RE: Potomac River Generating Station Site  
CDD #2021-00004  
Compiled City Comments for CDD Conceptual Design Plan Completeness  
christopher Project #17005.004.00

We are in receipt of your comments dated March 24, 2022 and offer the following in response.

EXHIBIT G - MEANDERING SIDEWALK AT NPS SIDE OUTSIDE PROPERTY LINE)

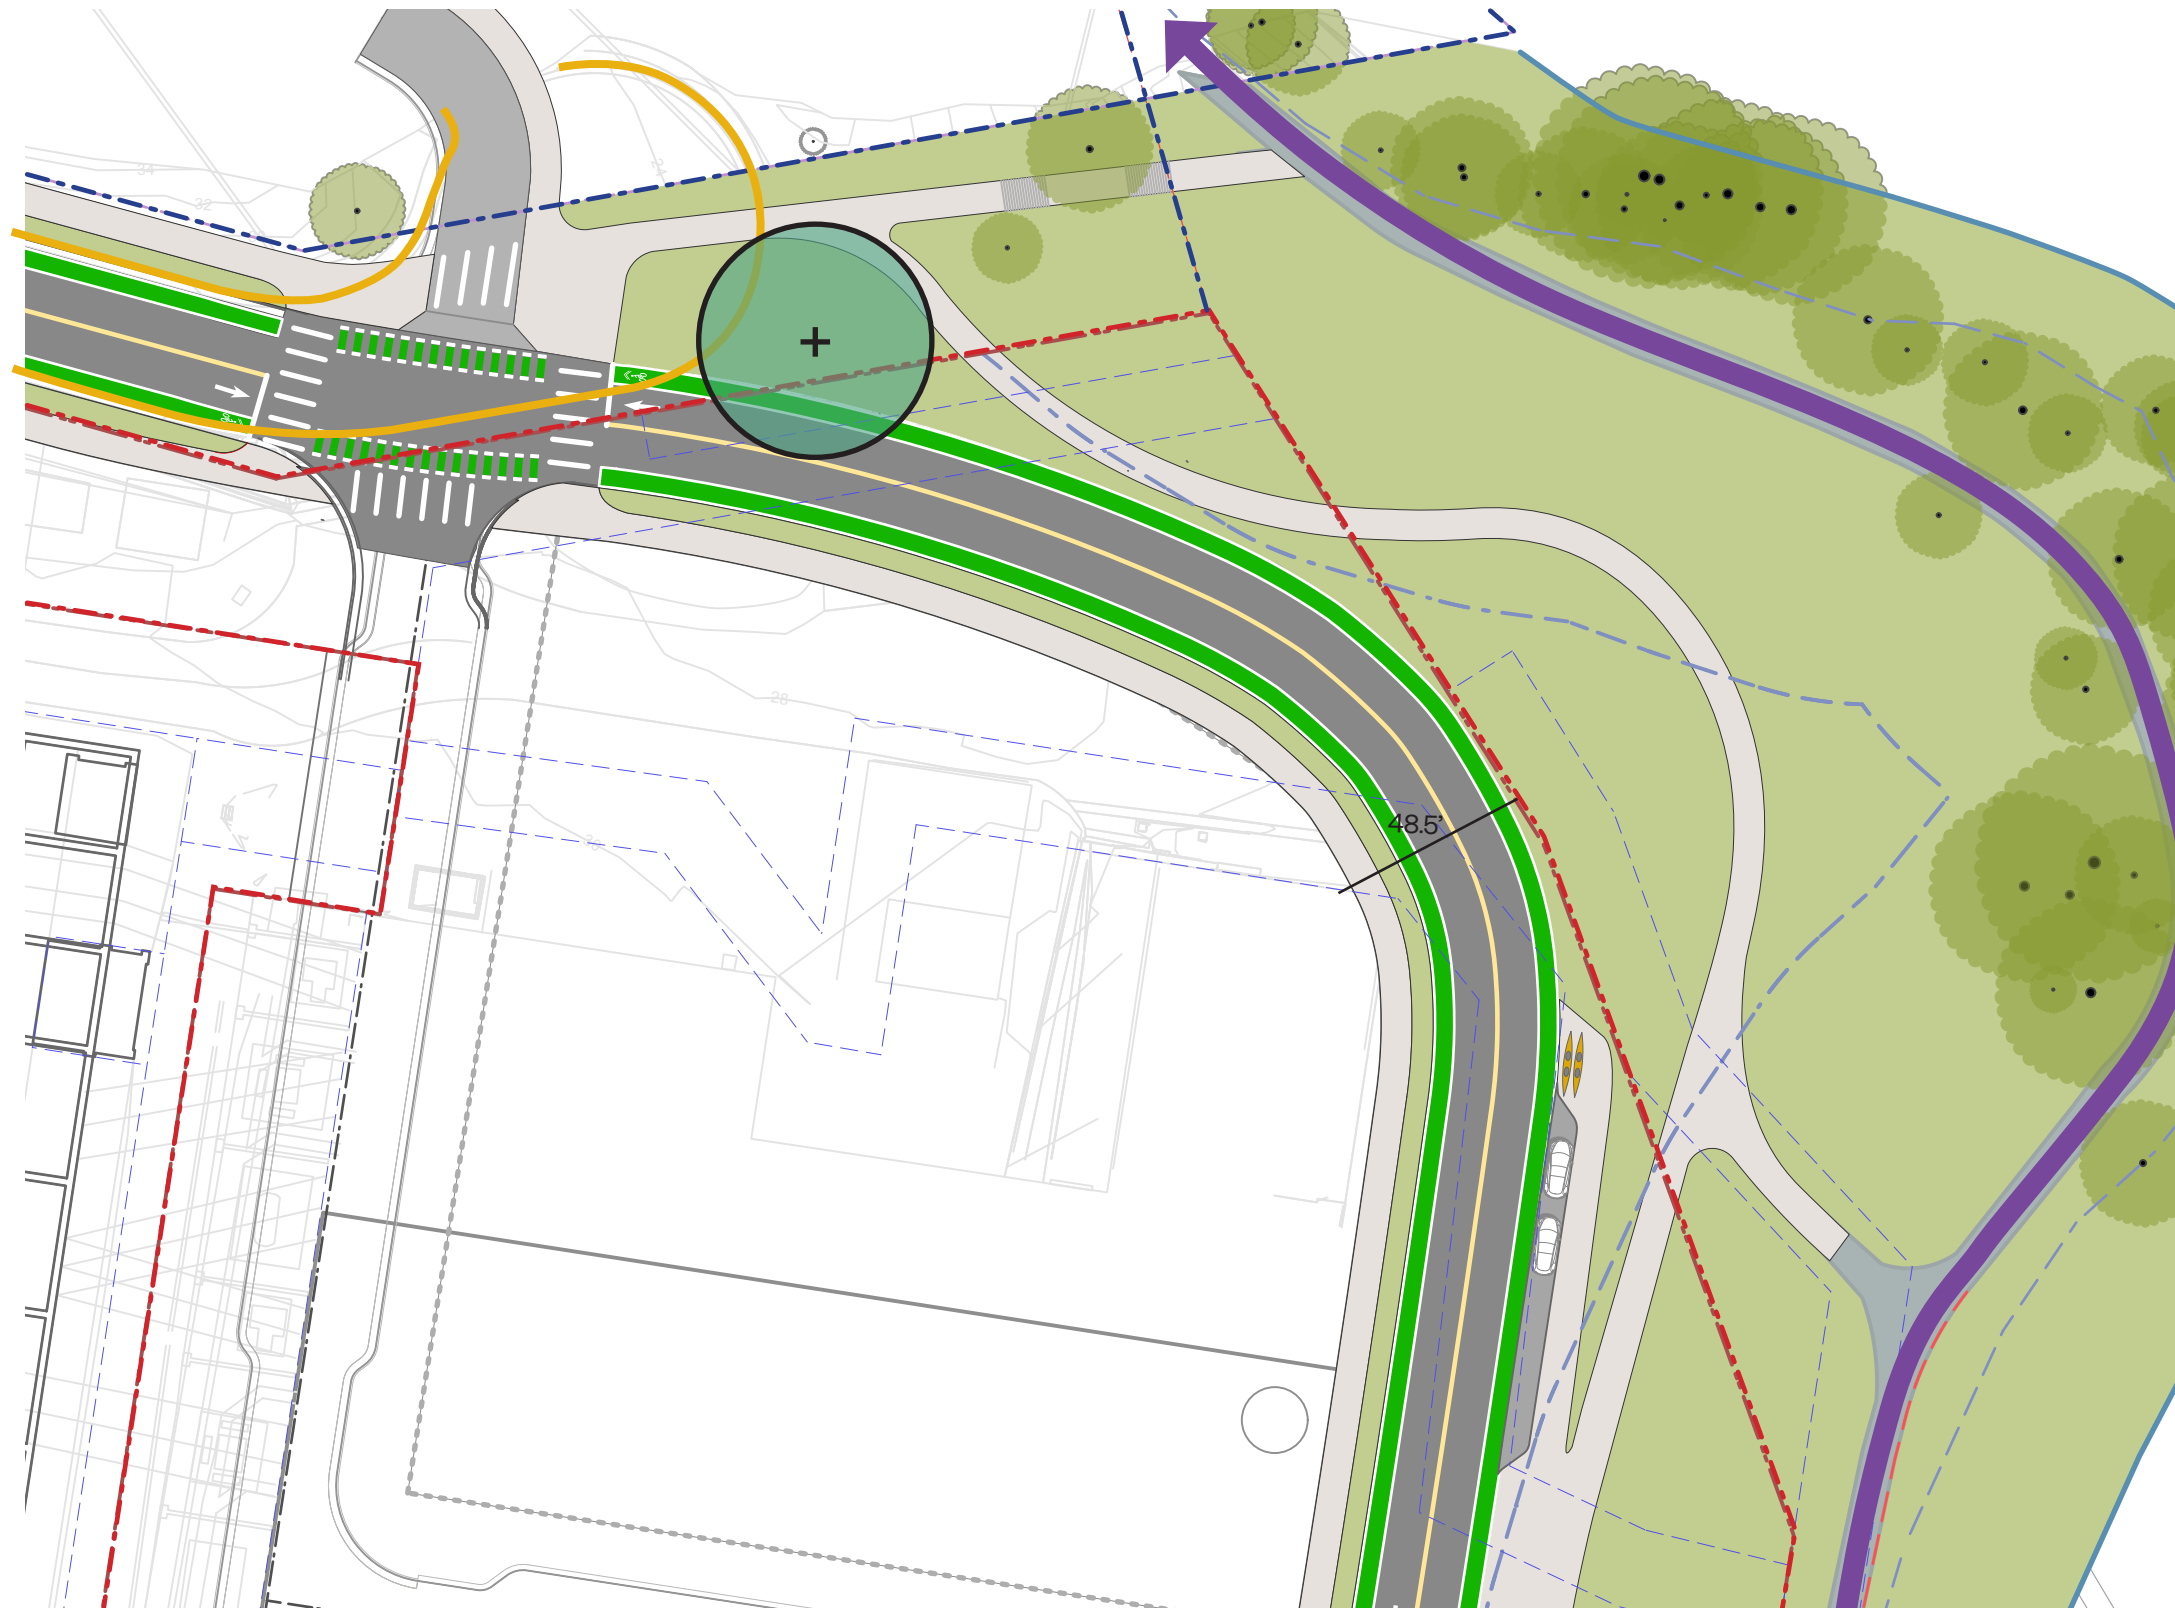
15. Provide additional visuals and/or information on the programming of the Slaters Lane street end. The extent of the maps that are part of the exhibits included in the comment response letter should include the entire adjacent Slaters Lane right-of-way, including the Slaters Lane street end that meets the Potomac River and Mount Vernon Trail.

4. Based on the findings of the Multimodal Transportation Impact Study, the applicant should be working with the City, NPS and other landowners on the following transportation network improvements:
  - a. Design and implementation of improvements to Slaters Lane
  - b. Improvements to the Slaters Lane and GWMP intersection including, but not limited to, dedicated bike facilities through the intersection, adequate sidewalk width and separation from the travel lanes, an additional north side crosswalk, lane configuration changes, and potential added turn lanes On Abingdon Drive for improved operation
  - c. Continuing to study the feasibility of providing an east-west connection between the site and the GWMP between Bashford and Slaters lanes.

Response: Acknowledged. Applicant added to this submission Exhibit G to show the proposed connection to Slaters Lane. Applicant will coordinate with the National Park Service on proposed program to their property, which is subject to federal approval.

- a. Acknowledged. Proposed improvements reflected in Exhibit G are the result of continued collaboration with adjacent landowners.
  - b. Applicant's proposed improved design (Exhibit G) for the intersection of Slaters Lane and GWMP balances multimodal facilities and vehicular operations at this intersection without roadway widening or other significant interventions as the City requests. Applicant commits to continued coordination with the City and NPS regarding the design, approval, and implementation of improvements to this intersection.
